ADDENDUM NO. 2

SUBJECT: Solicitation No. AA018B

TITLE: Miami International Airport (MIA) South Terminal Concourse H Rehabilitation – Phase 1

DATE:	FEBRUARY 4, 2022
SCALE:	AS SHOWN
DESIGN BY:	E.M.Z.
DRAWN BY:	C.N.Z.
REVIEWED BY:	E.M.Z.
PROJECT NO.:	18-0305.02
DRAWING TITLE:	SECTION & DETAILS
DRAWING NO.:	S1.07
SHEET NO.:	33 OF 42

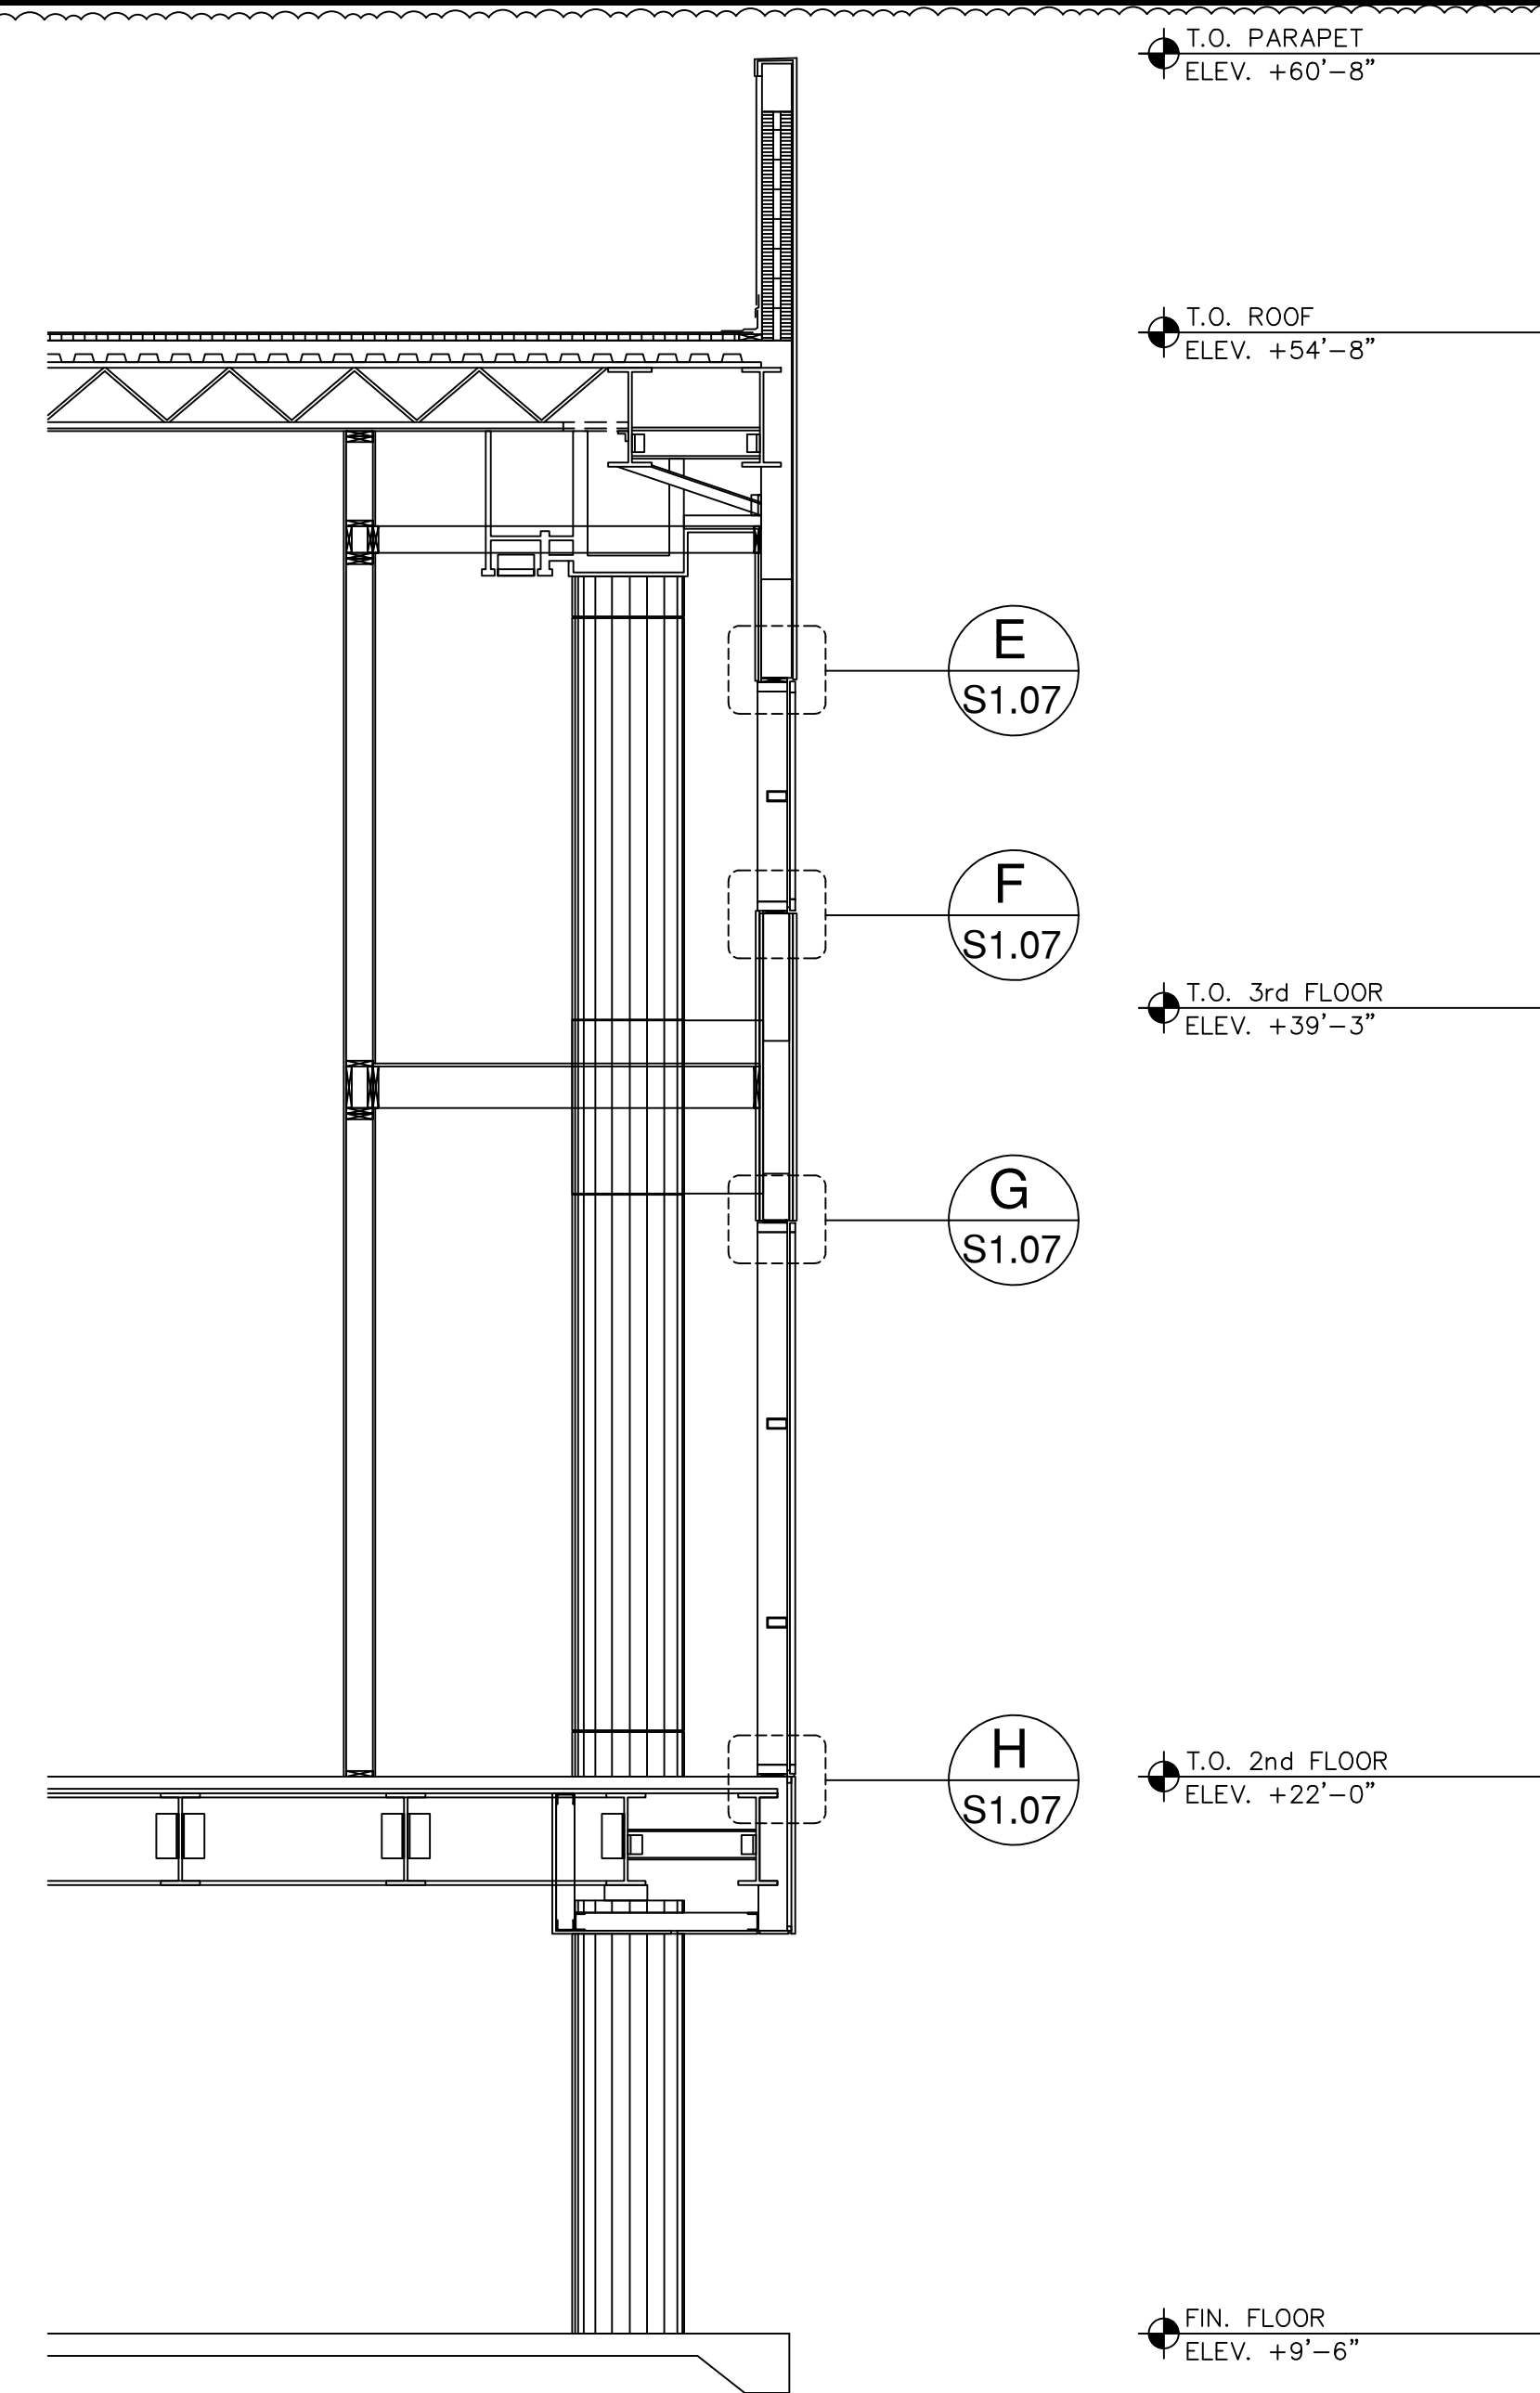
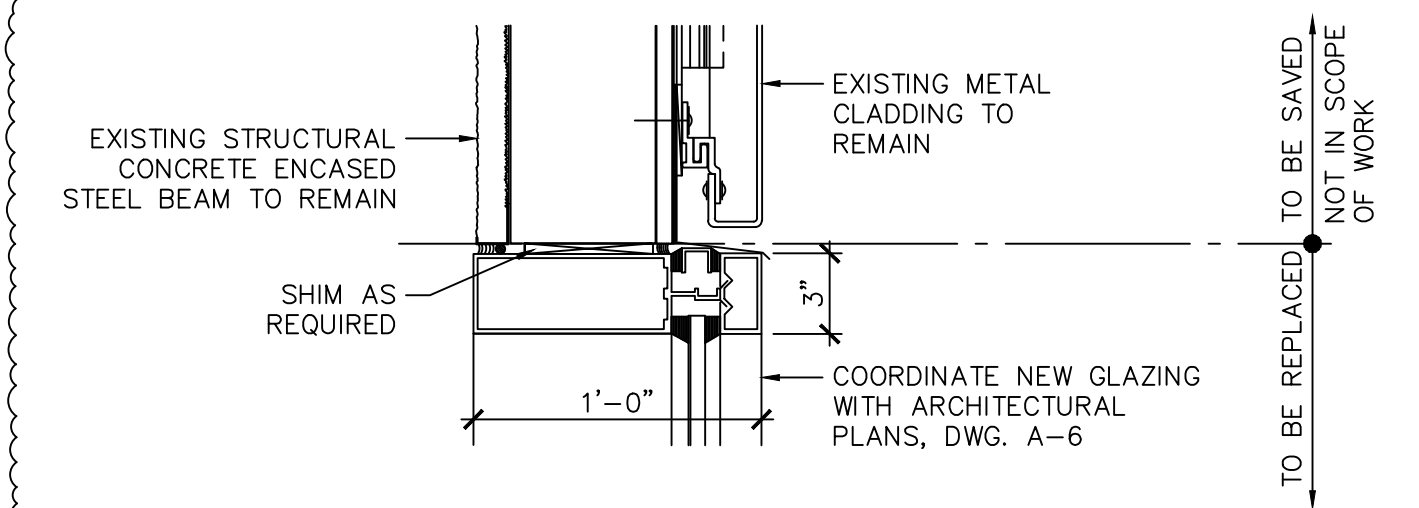
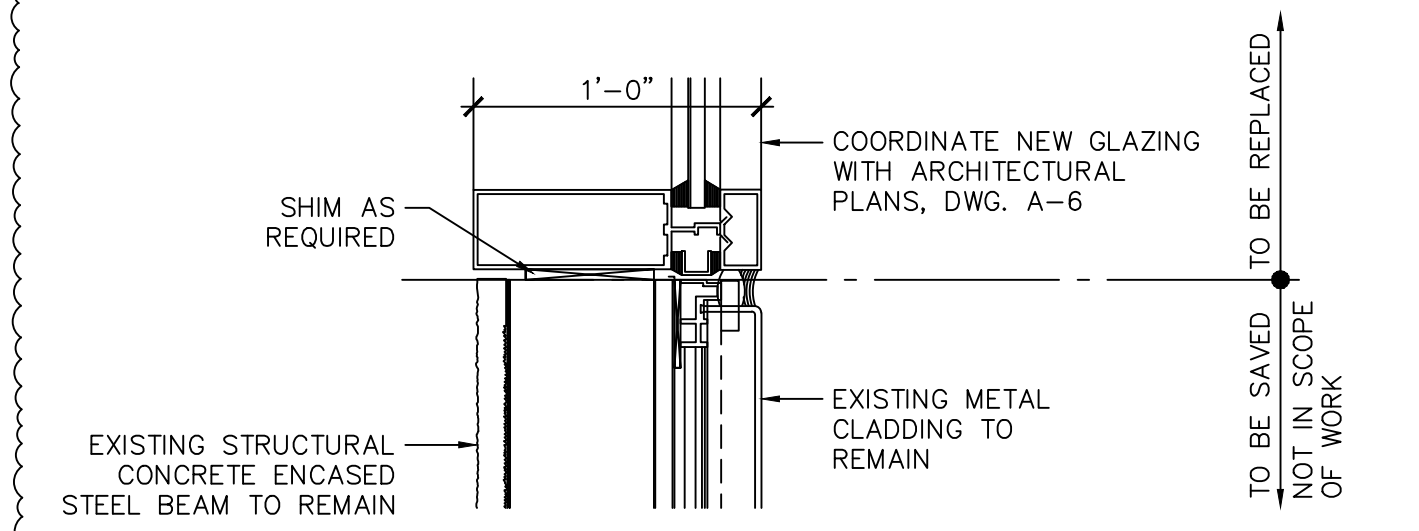
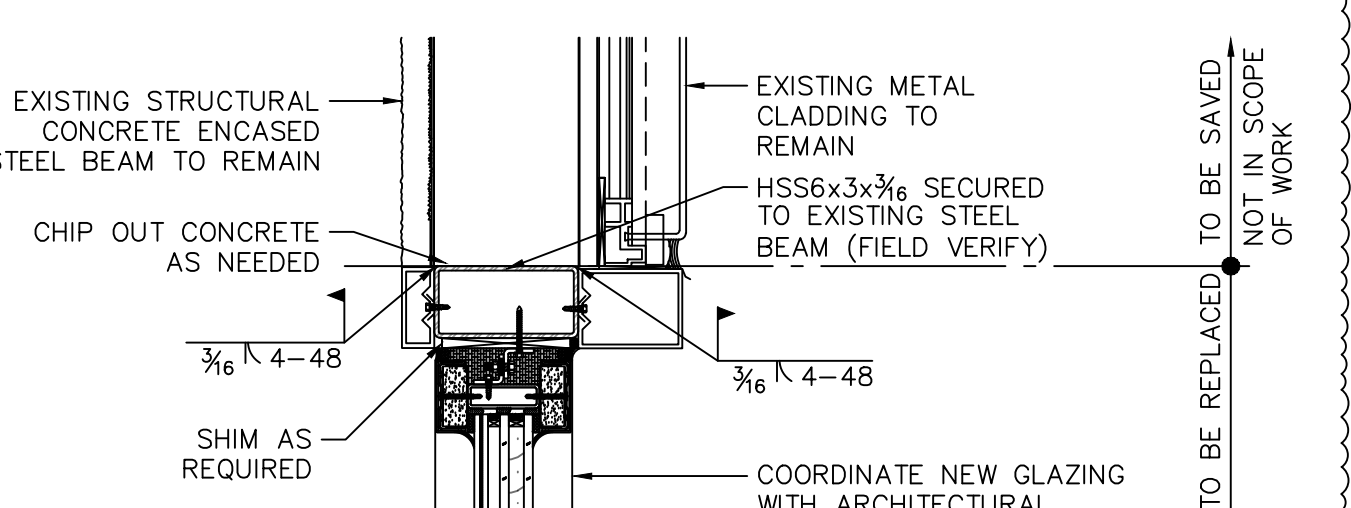
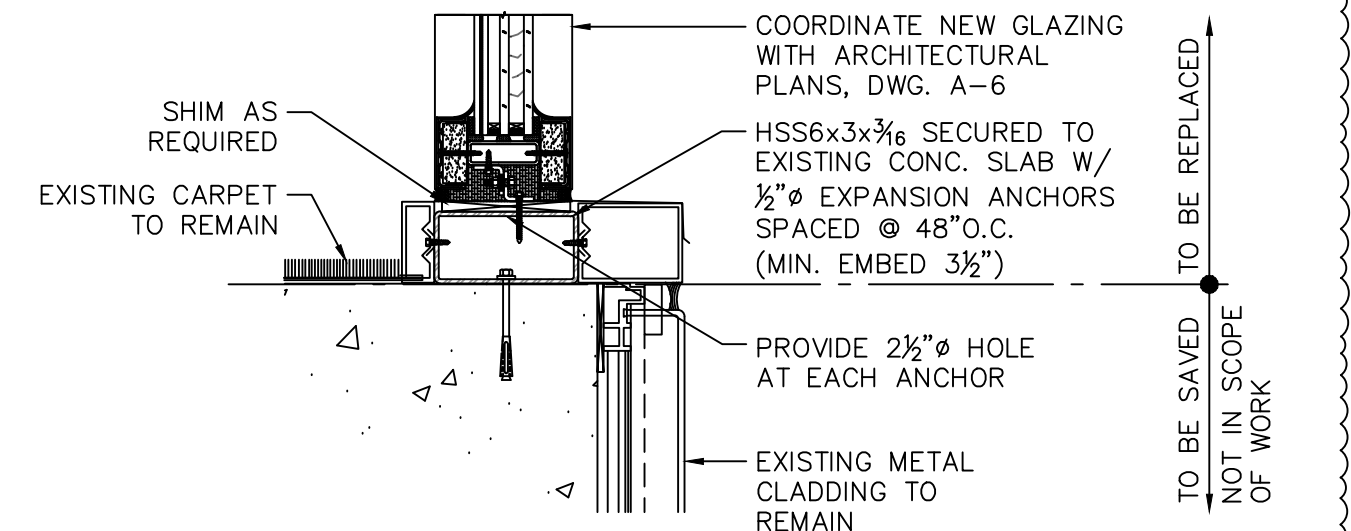
c. DRAWINGS S1.01 THROUGH S1.07 - Added section mark 2/S1.07 in work zones WZ-4, WZ-6/8, WZ-10 (DRAWING S1.07) Added section 2/s1-07, added details E/S1.07, F/S1.07, G/S1.07, H/S1.07
